5229 UNIVERSITY WAY NE

5229 UNIVERSITY WAY NE, SEATTLE, WA
SDCI Project #3032758-LU

Recommendation Meeting
NORTHEAST DESIGN REVIEW BOARD
Mar 31st, 2020

VIEW FROM UNIVERSITY AVE NE

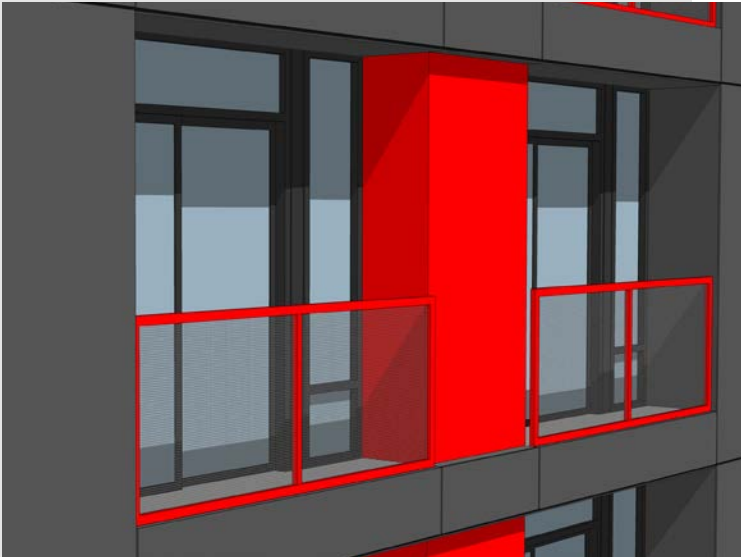
1. Massing and Design Concept: The Board had a wide-ranging and productive discussion of these issues, touching on the unique character of the University District, the role and importance of ‘fabric’ buildings on University Way, and the critical compositional elements of the various possible solutions on this small infill site. (DC2, CS3-1)

- a. The Board supported the applicant’s preferred option but agreed that any of the three schemes could be successful, including one (not proposed by the applicant) that eliminated the two-part composition of the upper levels in favor of one wellcomposed expression. (DC2-A, DC2-B)

- b. The Board questioned locating of all of the upper-level massing along University Way and suggested that depth and articulation could be developed on the street edge by taking advantage of buildable area deeper on the lot. (DC2-A, DC2-B, DC2-2, DC2-1)

- c. The Board agreed that flipping the principal entry to the north and retail to the south would create a more harmonious rhythm of elements at the street edge and would be a better response to context. (PL3-A)

The design has progressed with the development of the preferred option per the Board’s recommendation and developed it further with the Board’s suggestions in mind. The residential entry has been moved to the north of the property and the retail to the south as well. Taking the cues from the precedents in the area and the established street edge pattern, along with the Board’s suggestion about the facade composition, we felt that locating all of the upper level massing along University Way is appropriate and a better solution for this site. The upper levels are cantilevered so the ground level along the street edge can be pushed back further to create some outdoor space for the tenants and pedestrians alike.

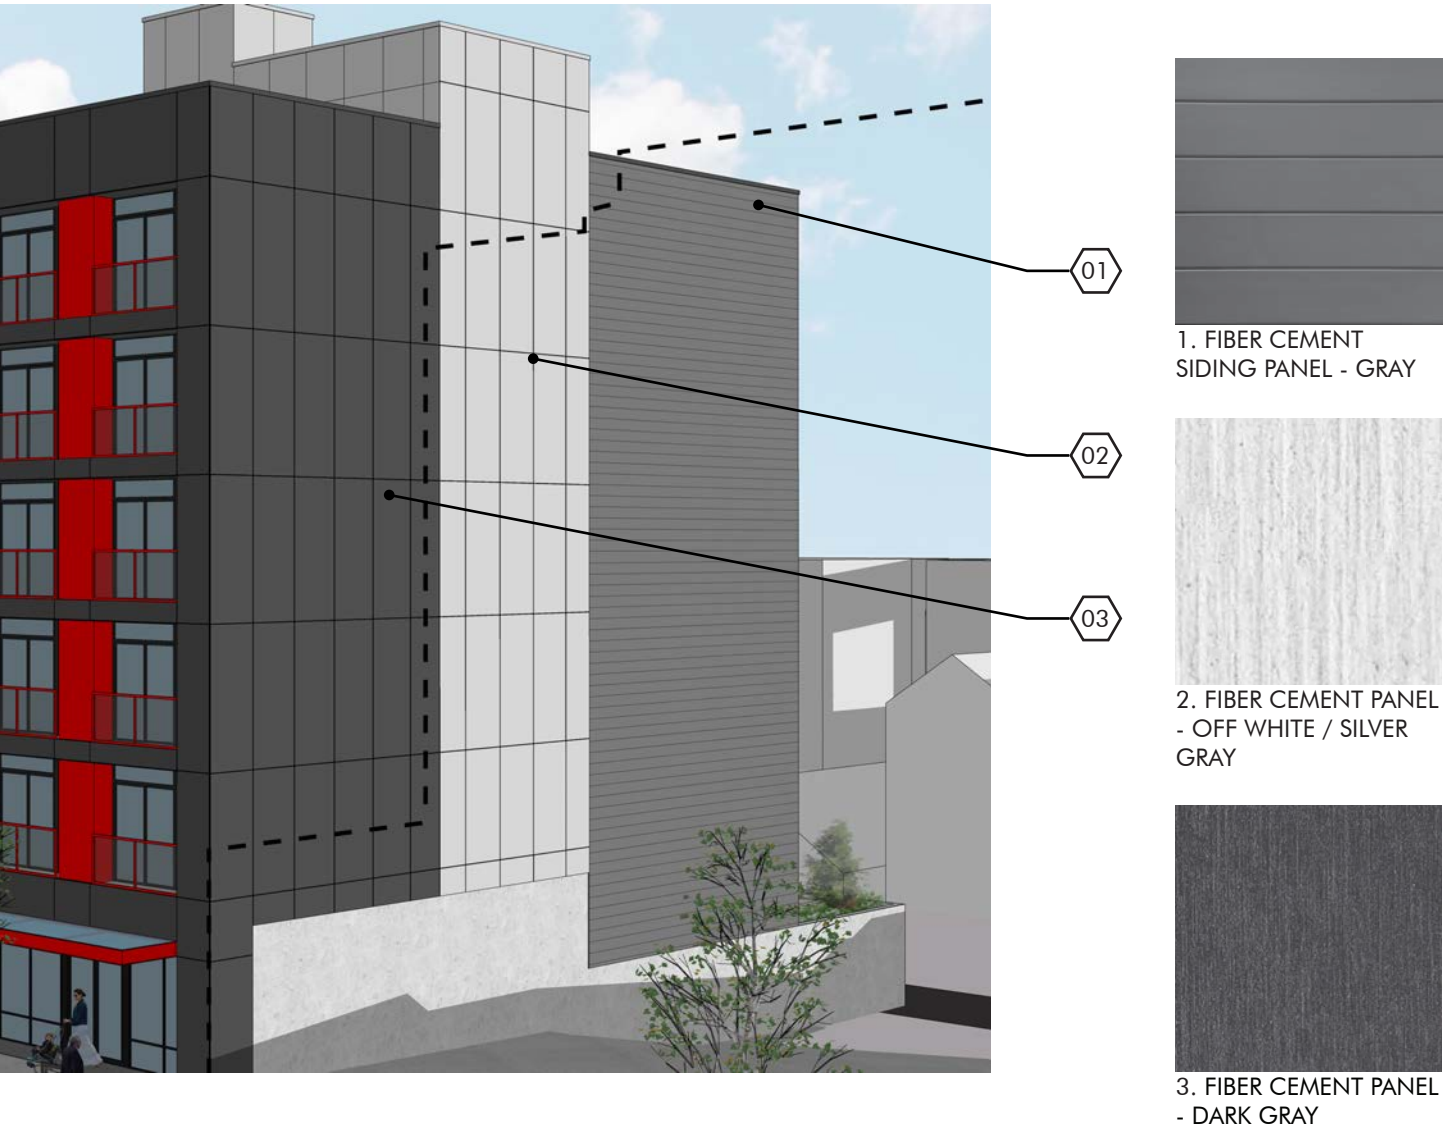
a. The Board, citing University Neighborhood Guideline DC4-1-a, agreed that a thicker, higher-quality cementitious board panel could be an acceptable cladding material, but encouraged the exploration of other high-quality materials. (DC4-1-a)

RESPONSE: The main façade treatment proposed is high-quality cementitious board panel along with high quality windows, metal accent areas, exposed finished concrete and perforated metal panels at the residential balconies. Glossy Laminate panels are introduced to create a color and contrast in texture to bring visual interest and hierarchy to the massing where the residential entry is located. Accent colored metal frames are employed around the recessed balconies to bring secondary modulation and vibrance to the facade.
